1 BUILDING 1000B - PROJECT LEVEL 4
SCALE: 1/8" = 1'-0"

PROJECT
RESERVE AT THE BALLPARK, PHASE II, AKA REVEL AT THE BALLPARK
2885 CRESCENT PKWY
SMYRNA, GA 30080

DATE: 05/22/2017
JOB NUMBER: 1493101
DRAWN BY: EKS/NB
CHECKED BY: CW
SHEET TITLE: BUILDING 1000B - PROJECT LEVEL 4
SHEET NUMBER: A1-14B
COMMENTS: BUILDING PERMIT RE-SUBMISSION
30X42 © 2017 The Preston Partnership, LLC

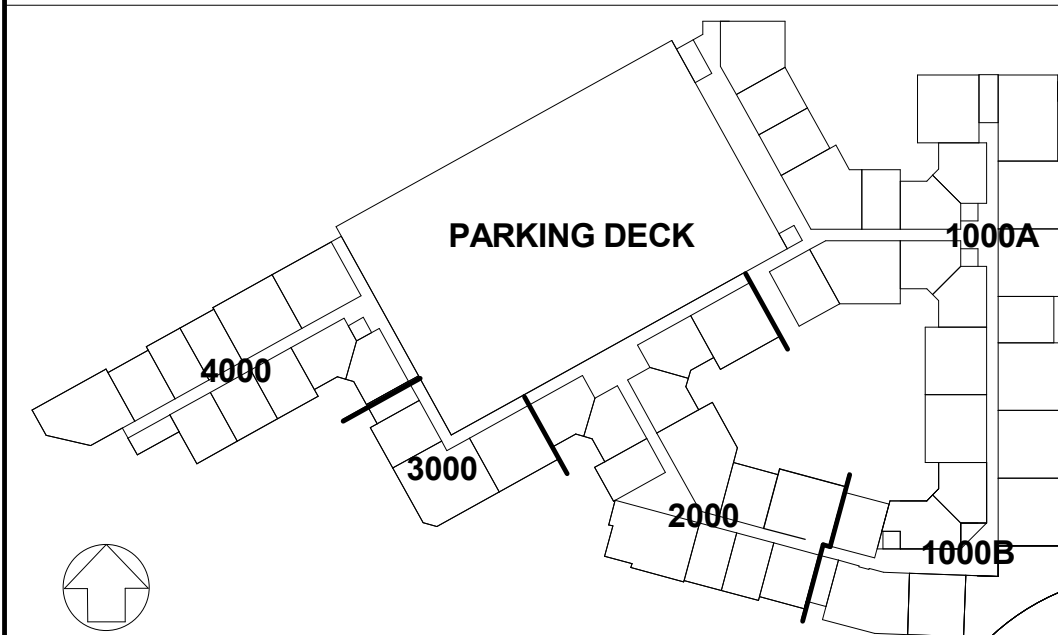
REVISION SUMMARY #1
A. CHANGED STAIR 2 TO STAIR C

REVISION SUMMARY #5
A. COMBINED 3 STORAGE ROOMS INTO 1 ROOM.
CHANGED DOUBLE MECH DOOR TO SINGLE DOOR
B. CHANGED WINDOW TYPE TO W5F
